## sPHENIX Response to PD-2/3 Report August 7, 2019

Brookhaven National Laboratory organized a Project Decision-2/3 (PD-2/3) review of the sPHENIX Project that was held on May 28-30, 2019 at BNL. The review charge is included in the appendix of this document. The final PD-2/3 review report has been provided to the committee as a separate document. The final report of the review committee contained six recommendations that are all addressed in this document.

### sPHENIX PD2-3 Final Report Recommendations:

Figure 5: Critical Path for sPHENIX MIE

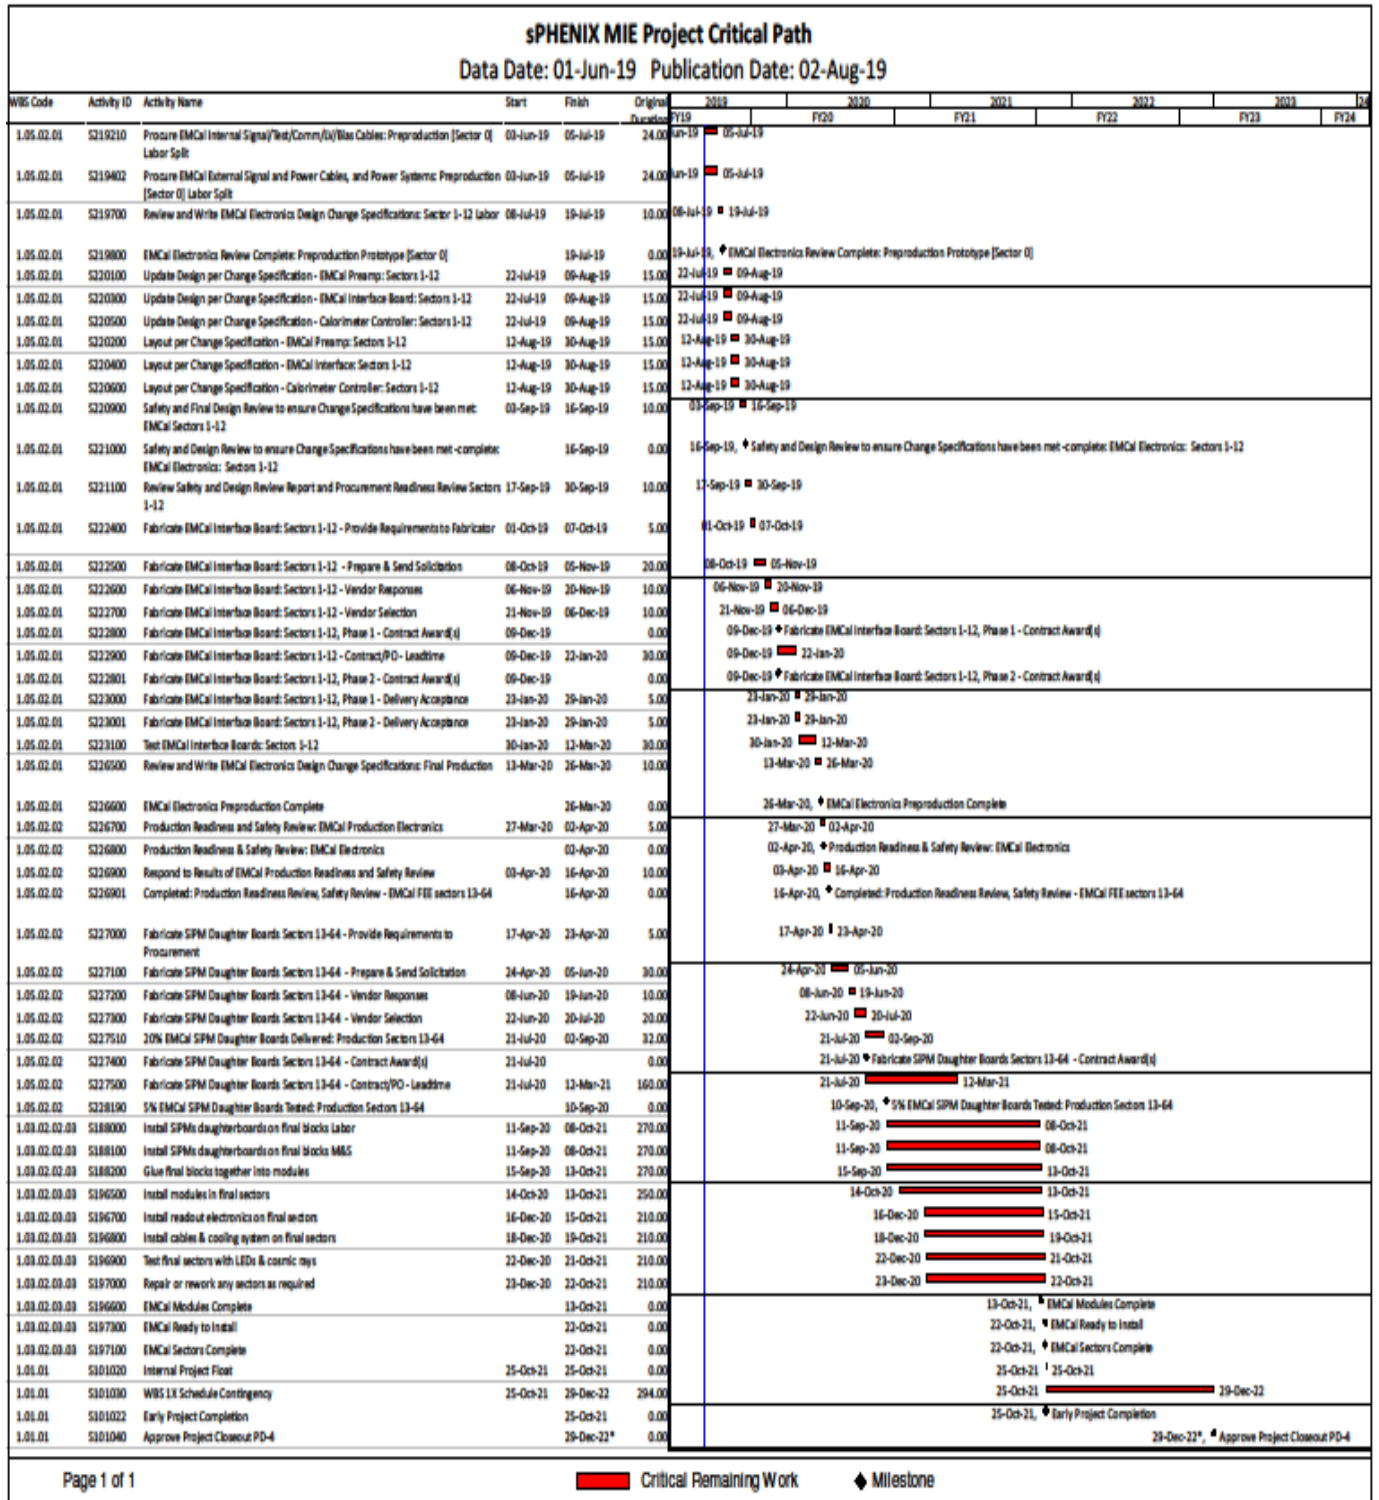
#### 1. The review committee identified cases of a high number of hours on activities with short duration in WBS 1.2 during Cost/Schedule Drilldown

#### 2. Review activities that should precede milestones in the schedule for reviews identified during Cost/Schedule Drilldown

4. **The Project Schedule has been frozen. The schedule contingency remains at 14 months. The early completion date is unchanged.**

The Project schedule has been stasused as of June 1 and the baseline has been established. The project early completion date is remains at October 2021 with 14 months of schedule contingency. The early finish date and schedule contingency remain unchanged from the PD-2/3 Review. (See Critical Path, Figure 5)

The Project schedule has been reviewed and the milestones dates and critical path have not changed. The critical path has made a few minor changes between elements of the work, but it remains confined to the calorimeter electronics work (WBS 1.5.2) in its earlier parts and the EMCAL production work (WBS 1.3.2) in its later parts, as before. We deliberately kept some schedule margin between EMCAL (WBS 1.3.2) and Calorimeter FEE (WBS 1.5.2) to allow for some activities being pushed into the future when we stasured the schedule and moved the data date. We paid particular attention to various links between activities and sections of the WBS, which improved our understanding of the activities driving the schedule and the critical path. A few unnecessary constraints were removed from the activities describing the installation of the EMCAL FEE (WBS 1.5.2) into the EMCAL Sectors (WBS 1.3.2.2). The schedule margin built into the EMCAL Electronics allowed us to preserve the Project Early Finish in October 2021 and the 14 months. See Figure 5 Critical Path and Figure 6 PMP Milestone Schedule.

Figure 8: Risk results from running the Monte Carlo on data in the revised risk registry.

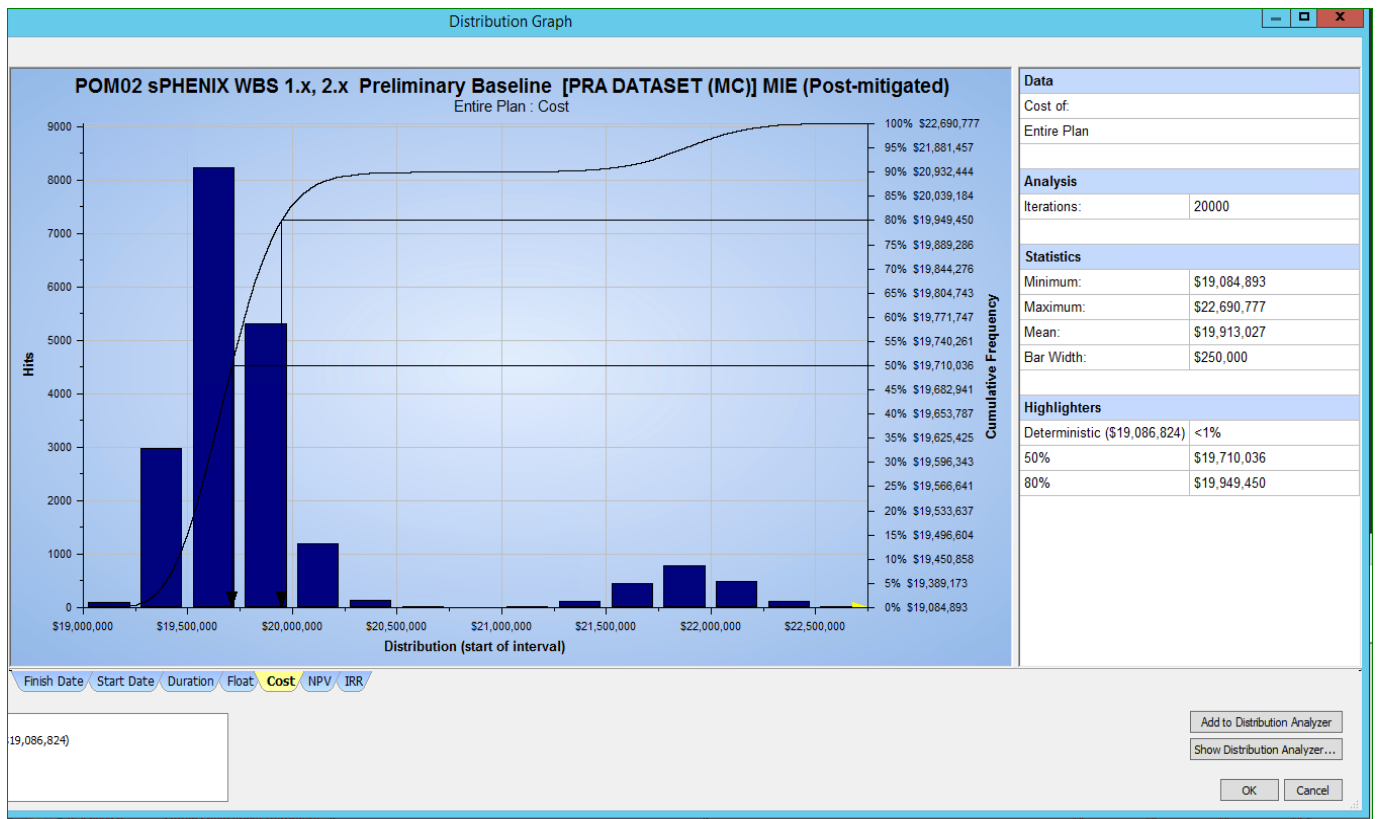
“Re-evaluate the contingency associated with large procurements such as the W powder, in view of the recent cost increase in this material and possible pending tariff situation. Once the above is satisfactorily completed, to the satisfaction of the sPHENIX Project Director and reported to the Review Committee, the EMCAL can proceed to PD-2/3.”

The probability of the risk “SAMPA Chip 80 nsec development” was increased from 5% to 20%, the probability of the risk “Tungsten Powder cost go up” was increased from 5% to 25% and the probability of all risks for electronics components was increased from 50% to 70%. After these changes were made to the risk registry, the Monte Carlo was run again which resulted in an increase to the Project Risk Contingency of \$181K to \$1,846K (See Figure 8 – Cost Distribution).

Figure 13: Gain achieved during each of the transfer field settings.

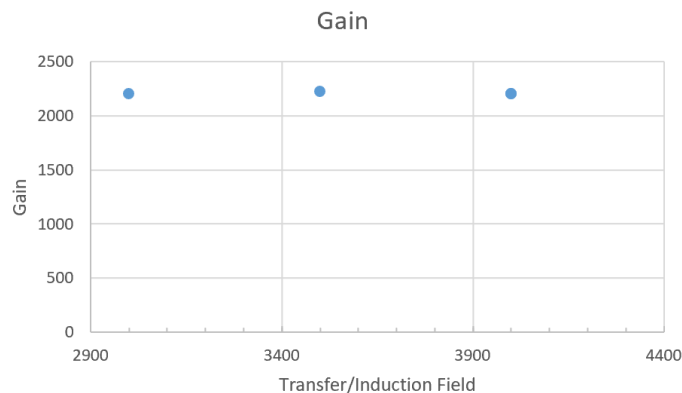
"Before PD-2/3, the TPC group needs to use their first set of preproduction chambers to simultaneously study the actual Ion Back Flow (IBF), energy resolution and discharge stability for their proposed gas mixture as a function of possible operating point settings for the full range of GEM voltages and transfer fields. This is to be done with the front mesh in place (if that continues as an option) to confirm that an operating point exists that meets all sPHENIX requirements with their proposed gas mixture."

Bench test results were performed as a function of transfer field with  $E_{T1}=E_{E2}=E_{ind}$  and  $E_{T3}=100\text{Volt/cm}$ . At each value of the transfer field, the gain of the module was adjusted using the GEM voltages so as to achieve a value near 2000 (2200 was close to the average). These results are shown in Figure 13.

Figure 16: Top plot shows the pedestal distributions over 32 channels (one SAMPA chip) before irradiation. Bottom plot shows the pedestal distribution over 32 channels after 100 krad irradiation.

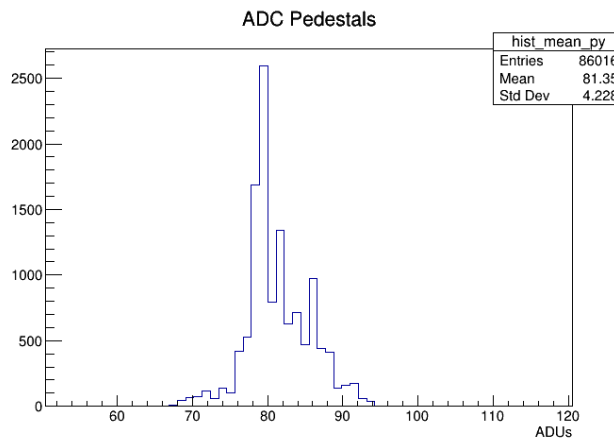
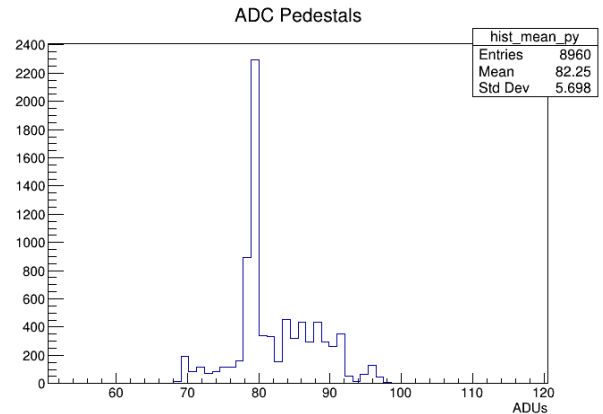
“As indicated in last year’s review, all components on the TPC FEE board needs to be radiation-qualified; this has been largely achieved but some tests remain. Demonstrate the performance of (two) full TPC FEE boards with SAMPA V4 ASICs versus dose up to a TID of at least 100 krad. Once available, repeat this demonstration using full TPC FEE boards with SAMPA V5 ASICs. The Committee then recommends proceeding to PD-2/3.”

The plots below show the pedestal distributions over 32 channels (one chip) overlaid, before and after 100 krad irradiation. The left plot is before irradiation and the right is after irradiation. They look very similar given the statistics, **proving that the SAMPA and the other survived parts function normally after 100 krads of exposure.**
